Aleksey Rezvoi

In the presented document, the ongoing impact/influence of LWR fuel requirements is being felt. It is probably very difficult to get rid of this. If this does not work and it is impossible to abstract, it is proposed to separate the LWR requirements. And even highlight them in a separate section or even in a separate document.

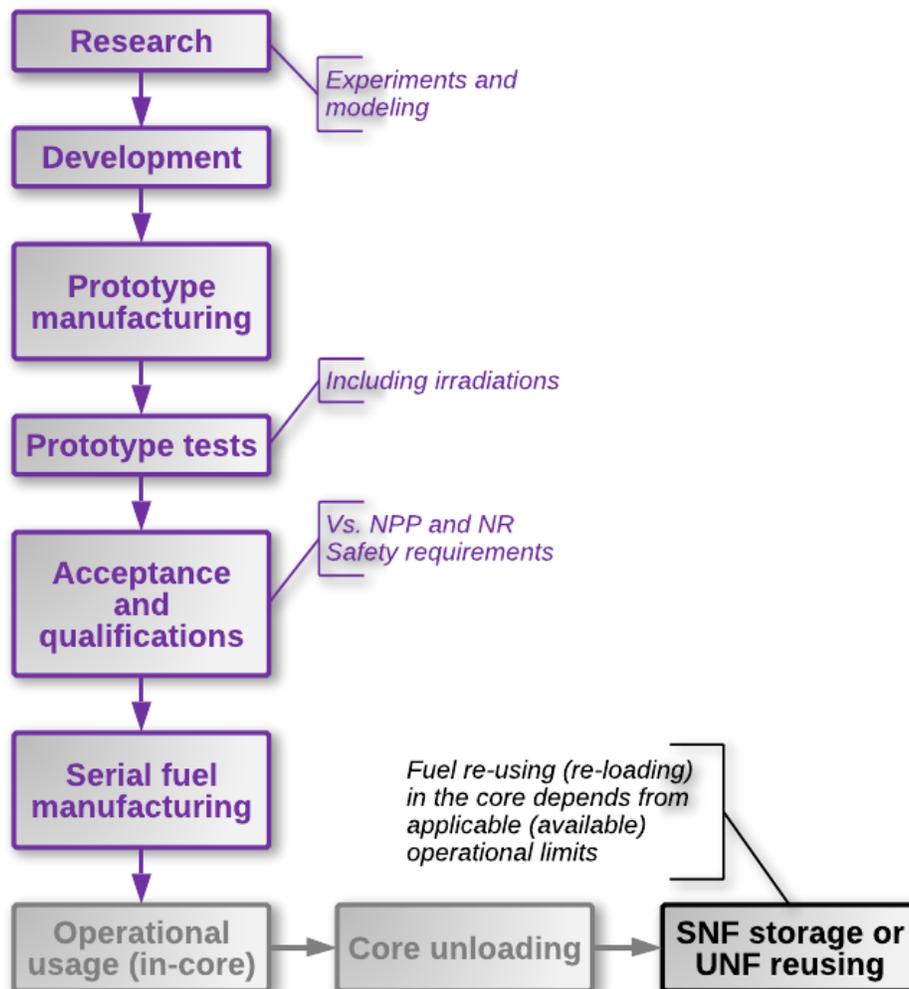
The main goal decomposition does not seem correct (Fig. 3.1). G1 and G2 not only goals for fuel qualifications. The manufacturing process and safety criteria vs. qualification? Truly not sure about it. Can you formalize, which "fabrication parameters significantly affect" what? At the same time, below "complete manufacturing specification is not expected as part of the licensing documentation"...

I have recreated the full diagram for subsections 3.1. and 3.2. See the figure for notes. Probably easy to understand author's ideas with this diagram.

Diagram block G.2.1.1 has connections to two different blocks (for example). But these blocks are different in nature and cannot be substantiated simultaneously. Otherwise, this is not correct from the technical point of view.

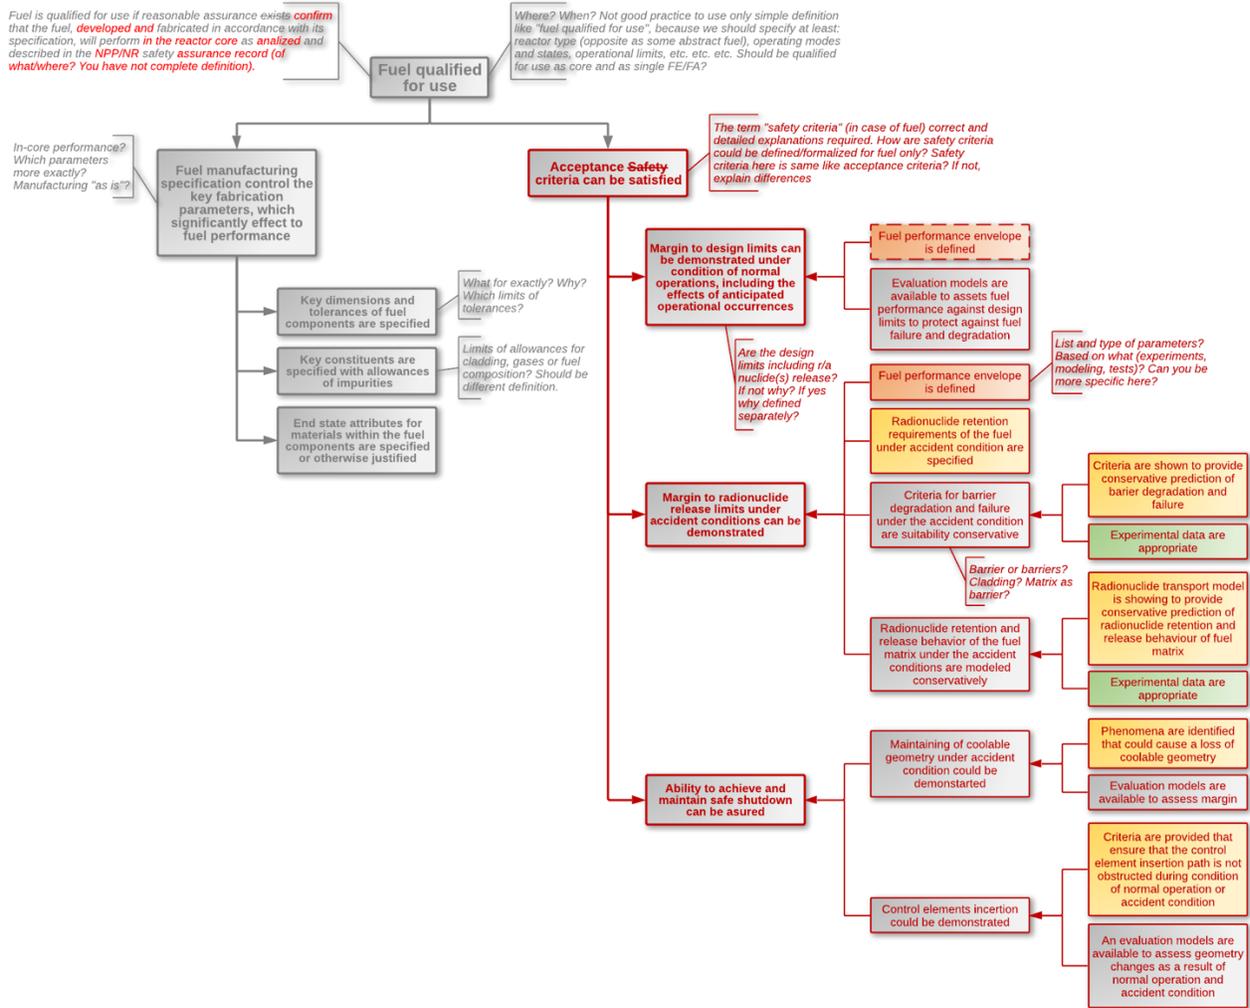
Additional remarks about your document would be presented on diagram (see below).

Based on presented information, document authors considering fuel qualification as fuel manufacturing "as is" (only) vs. safety criteria (see diagram). At the same time, authors trying to give advises about modeling and research (experiments) approach (mentioned in my remarks above). Not seems correct approach.
